**HORIZONTAL DIRECTIONAL DRILL ANALYSIS  
WETLAND J-47 CROSSING  
PADEP SECTION 105 PERMIT NO.S:  
PA-LE-0001.0000-SR & PA-LE-0001.0000-SR-16  
(SPLP HDD No. S3-0090)**

**WETLAND J-47 CROSSING  
PADEP SECTION 105 PERMIT NO.S:  
PA-LE-0001.0000-SR & PA-LE-0001.0000-SR-16  
(SPLP HDD No. S3-0090)**

RE: Sunoco Pipeline, L.P. Pipeline Project - Mariner East II  
Wetland J-47 Horizontal Directional Drill Location (S3-0090)  
Hydrogeological Reevaluation Report  
Conewago Township, Dauphin County and  
South Londonderry Township, Lebanon County, Pennsylvania  
RETTEW Project No. 096302011

Figure 1. Original 20-Inch HDD Plan and Profile

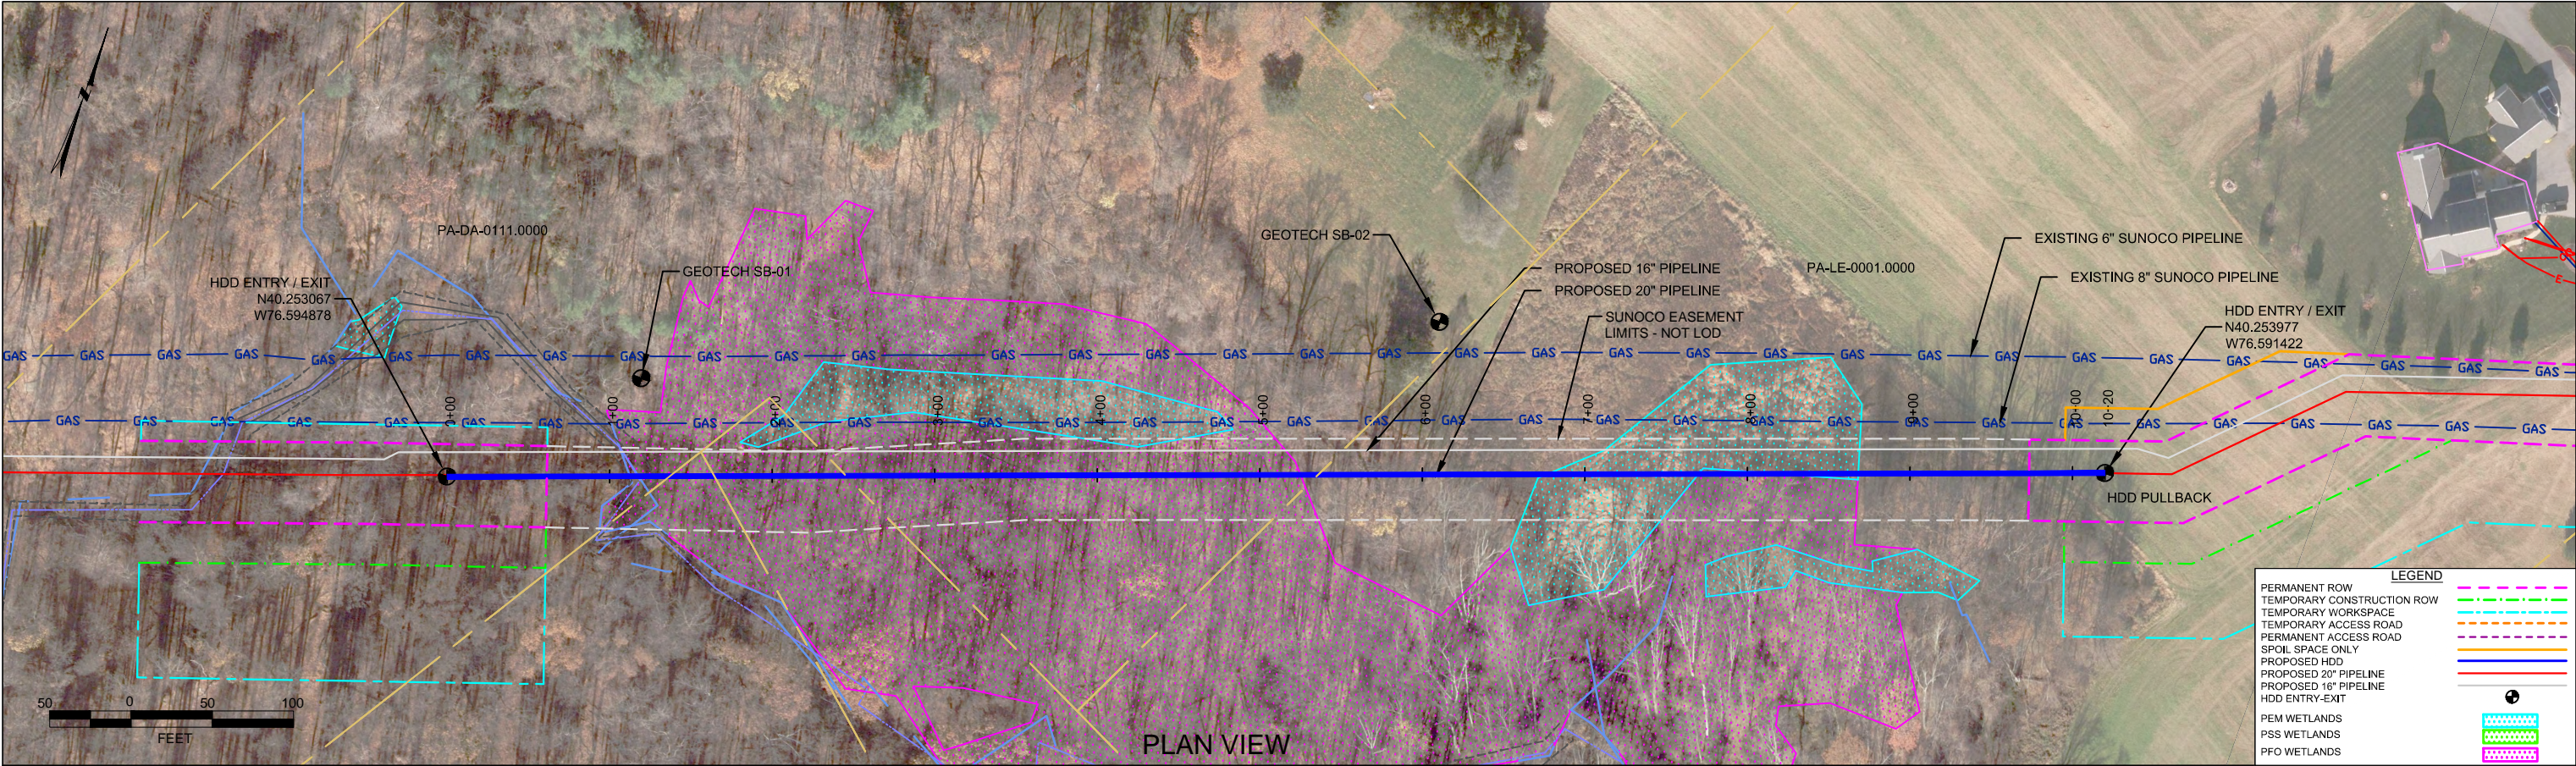
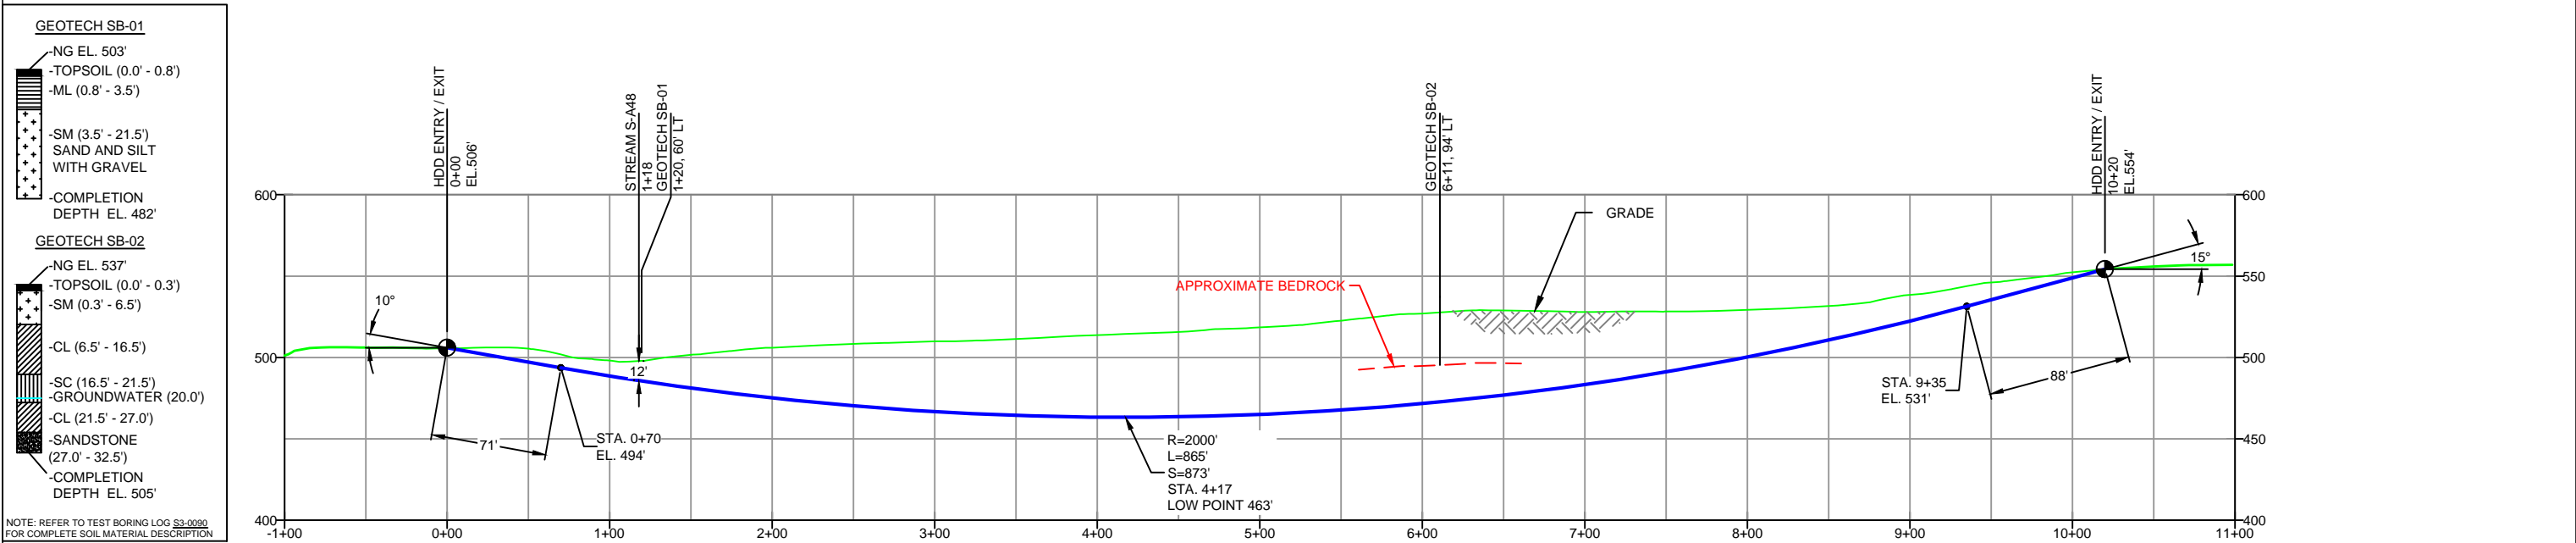
- Horizontal length: 1,020 foot (ft)
- Entry/Exit angle: 10-15 degrees
- Maximum Depth of cover: 60 ft
- Pipe design radius: 2,000 ft

HDD specialists for Sunoco Pipeline, L.P. (SPLP) reviewed the original HDD designs summarized above, and predicted that the design profiles for the 16 and 20-inch HDDs would produce an IR at or before 100 ft into the pilot profile for either pipe, where the drill crossed the first stream, and an IR to a water of the state may occur.

Figure 2. Revised 20-Inch HDD Plan and Profile

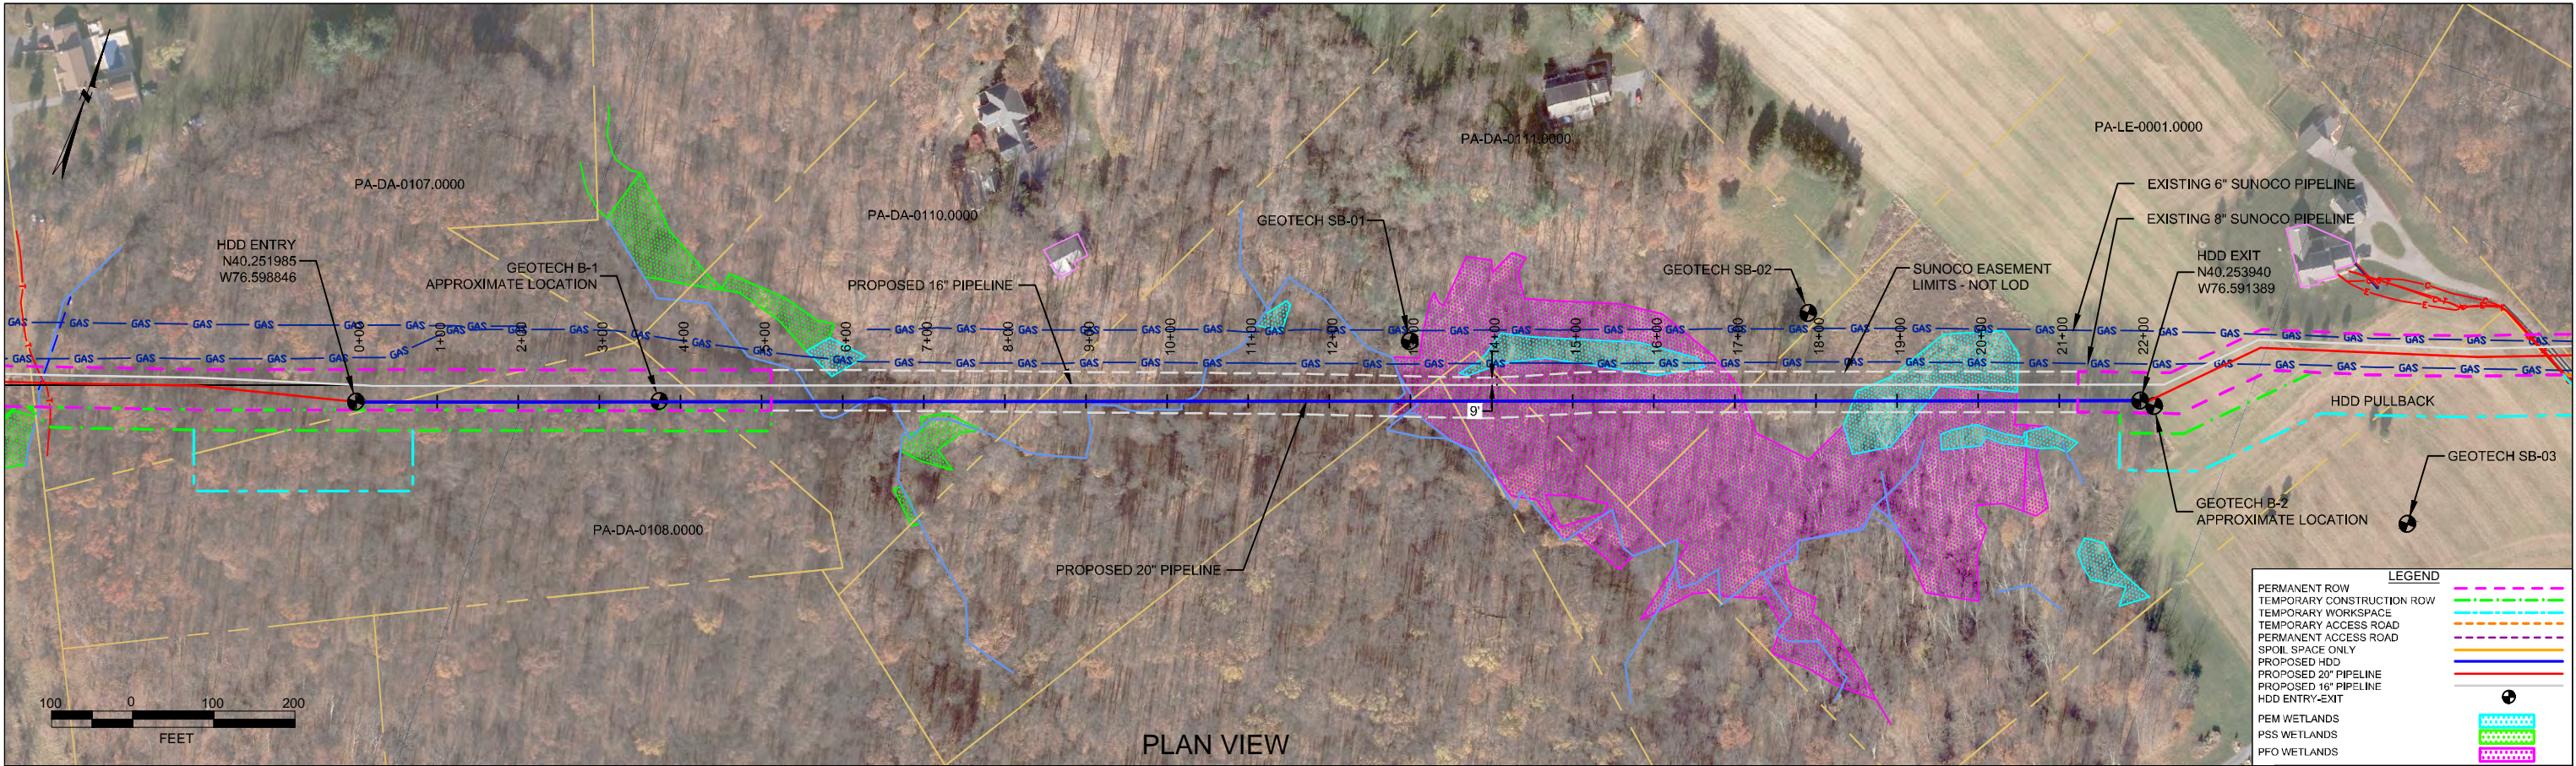
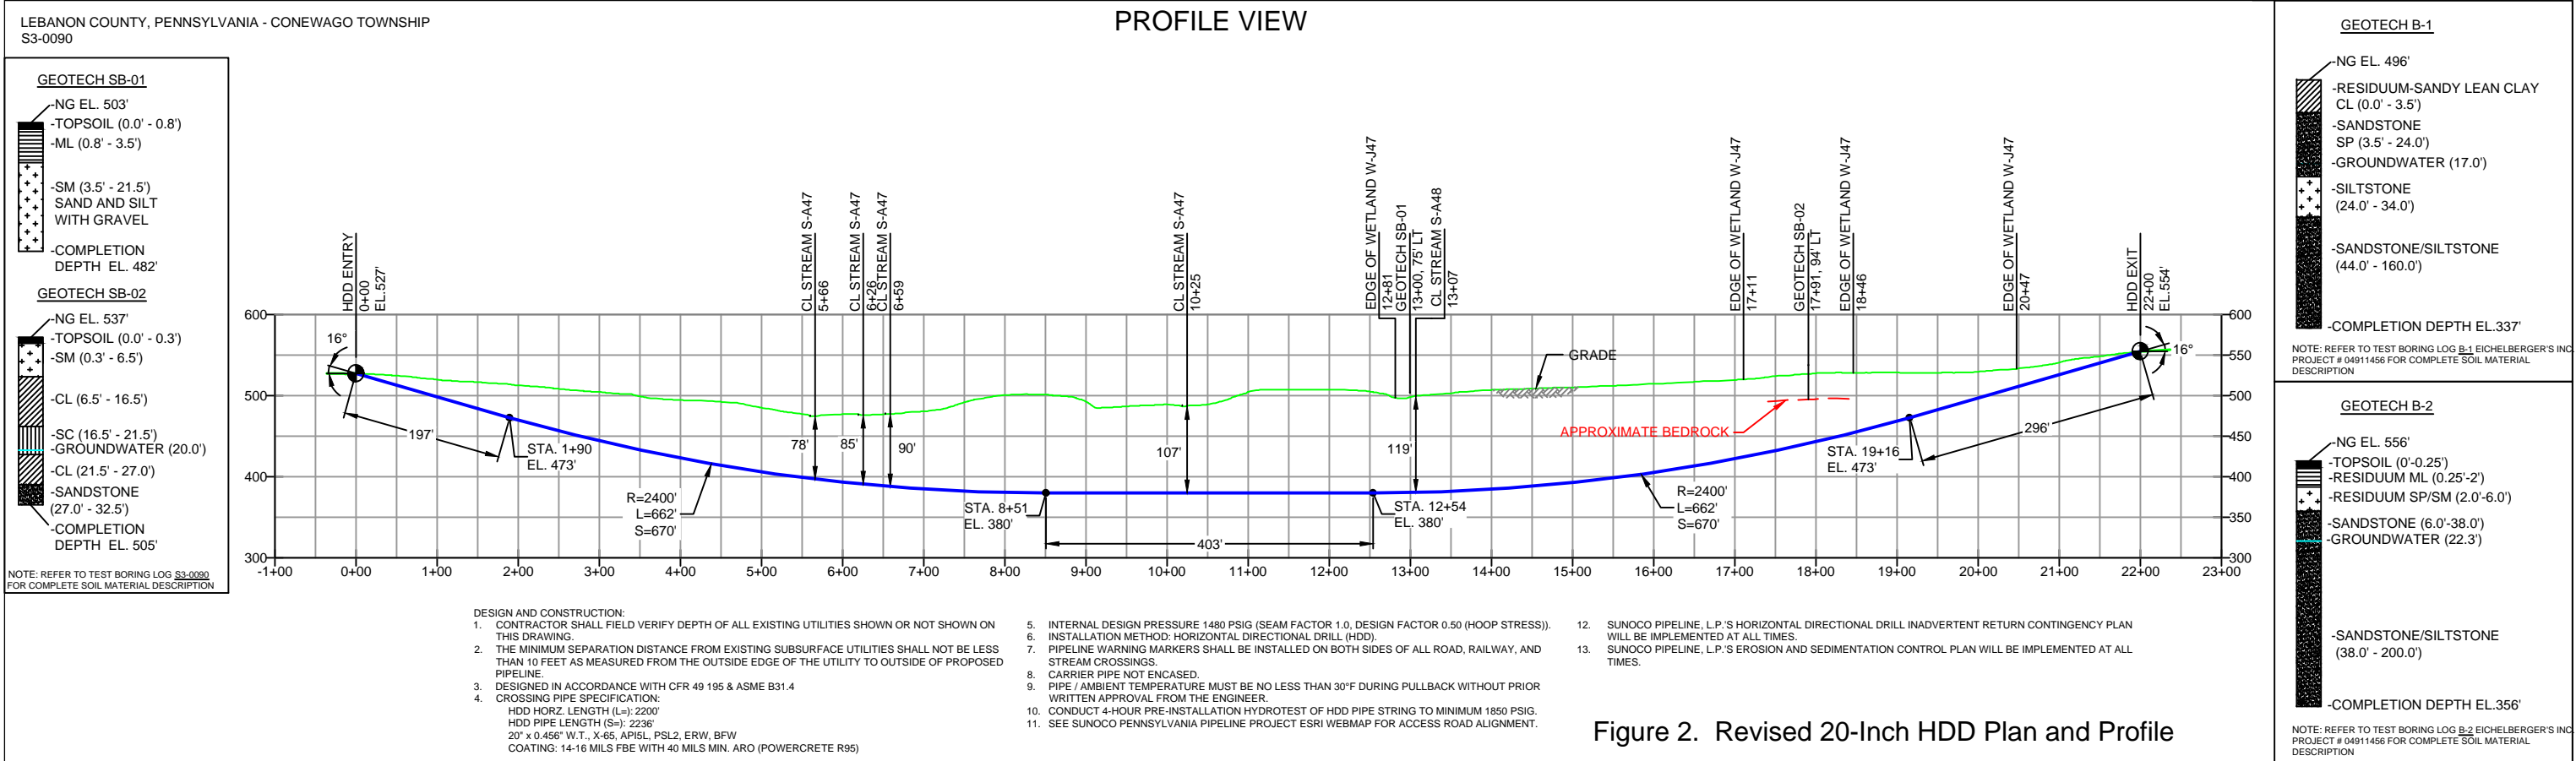
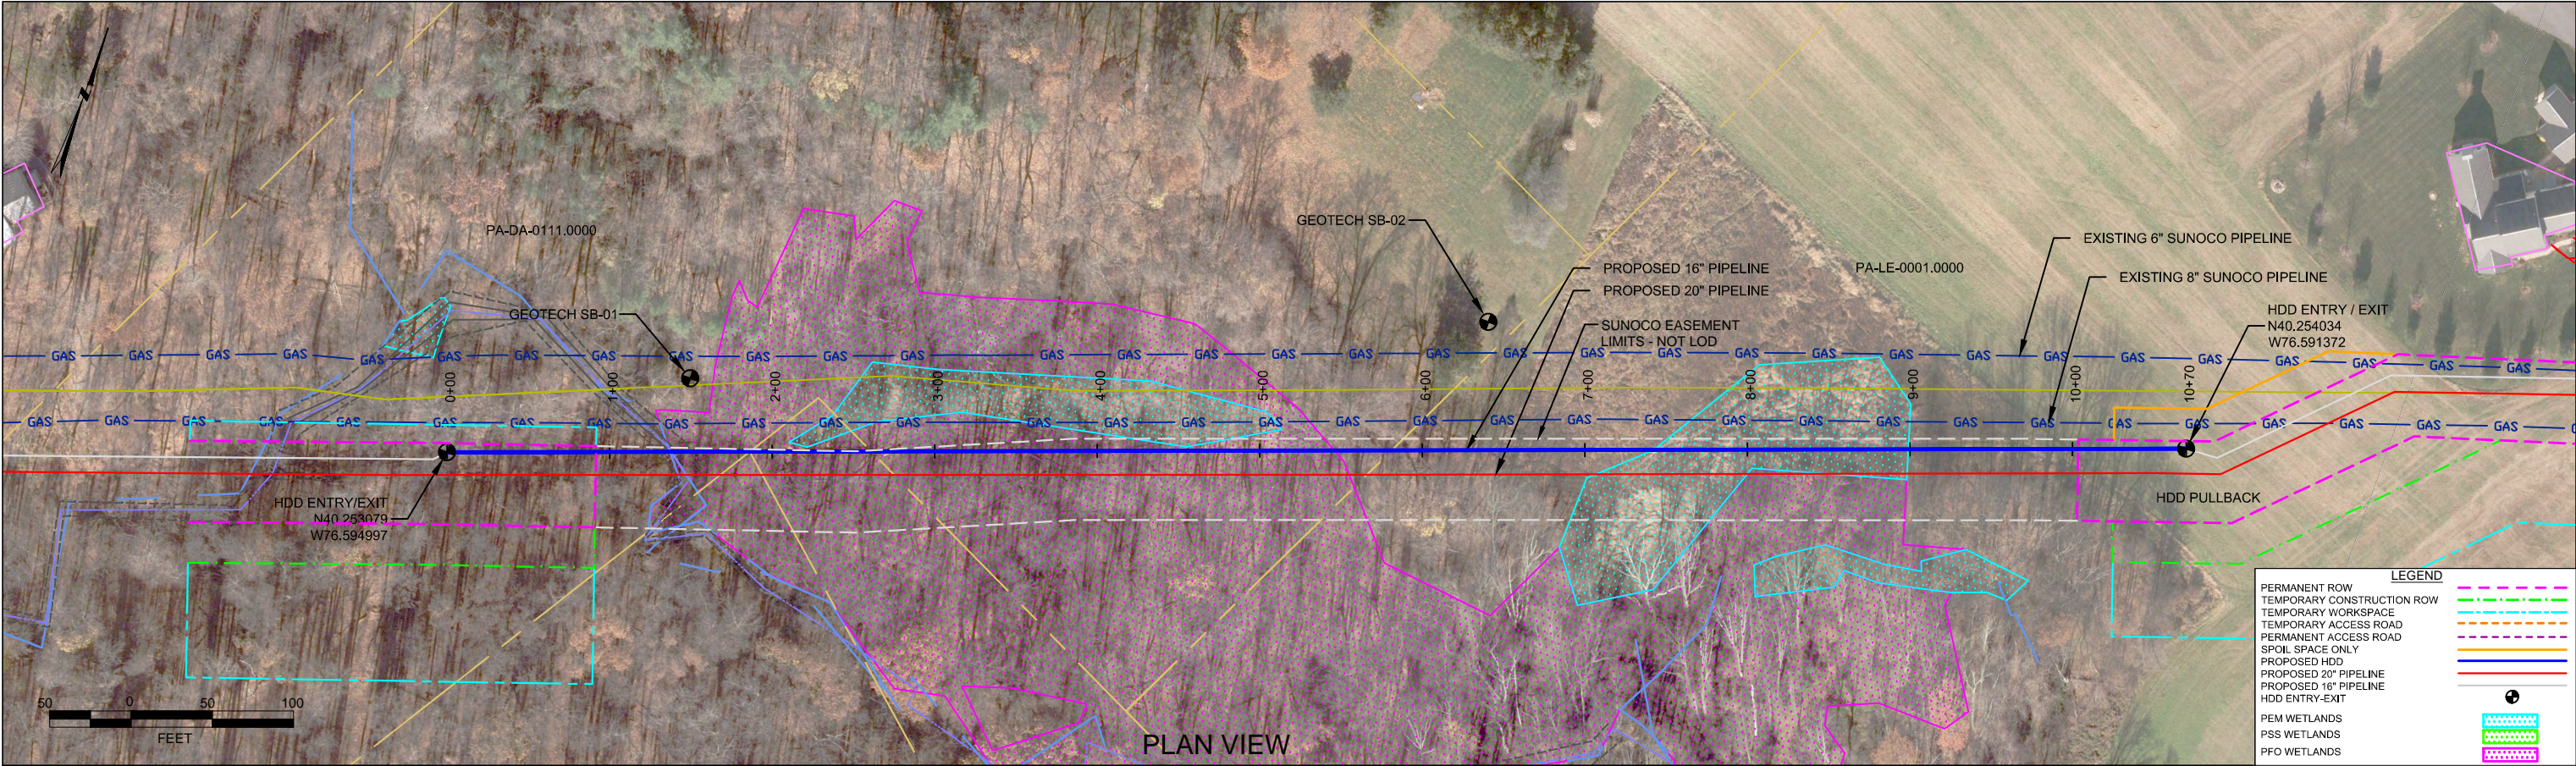
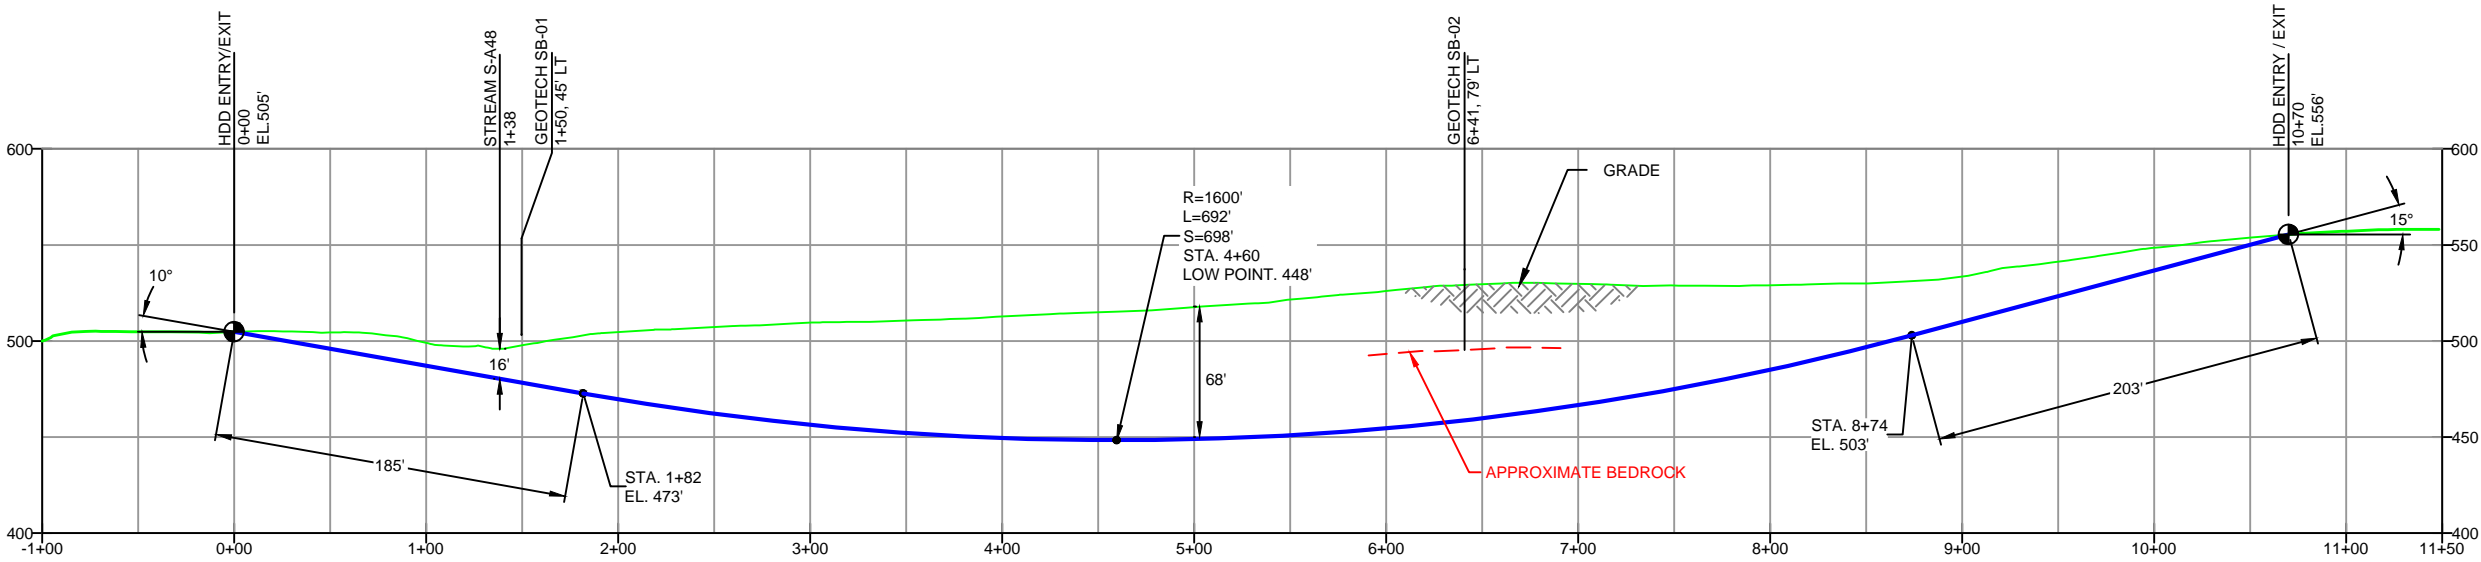
As shown on Figures 2 and 4 in Attachment 2, the weakest point in both profiles is the first stream undercrossing, occurring at Station 5+66 on the 20-inch profile, and Station 5+33 on the 16-inch profile. The revised design profiles provide for 78 ft of cover above the 20-inch pilot drill, and 91 ft of cover over the 16-inch pilot drill.

As shown on Figure 2, the redesigned HDD profile for the 20-inch pipeline is 1,180 ft longer, with a maximum depth of cover increased by 59 ft from the permitted design. In addition, the entry/exit angles have been increased from 10-15 degrees to 16 degrees allowing for a sharper and quicker descent into more competent rock. As shown on Figure 4 the redesigned HDD profile for the 16-inch pipeline is 1,130 ft longer, with a depth of cover increased by 62 ft, and designed for a sharp and quick entry and exit from the horizontal depth.

- Horizontal length: 2,200 ft
- Entry/Exit angle: 16 degrees
- Maximum Depth of cover: 119 ft
- Pipe design radius: 2,400 ft
